INDESIT company

Model type:
AVD169EU

Commercial code:
F029848

Fig . 001

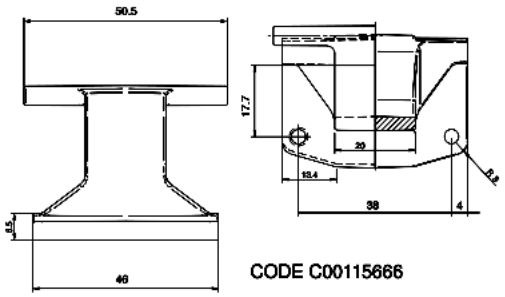
n1040349: Introduction of 150° Zamac hinge on Ariston 46 models.

From serial no. 50207.0001, all Ariston models produced in the Teverola factory (see table 001 attached) with industrial code (given on the rating plate) starting with 46, have been equipped with a Zamac hinge with 150° opening angle, code C00115666

(see Fig.001).
This modification has involved the introduction of the following items:

The premodified items are not interchangeable separately with the modified ones.

Code C00115670 - Complete door EVOII 150° white 27 with standard glass;
Code C00115674 - Complete door EVOII 150° white 27 with long glass;
Code C00115667 - EVOII body for 150° hinge white 27;
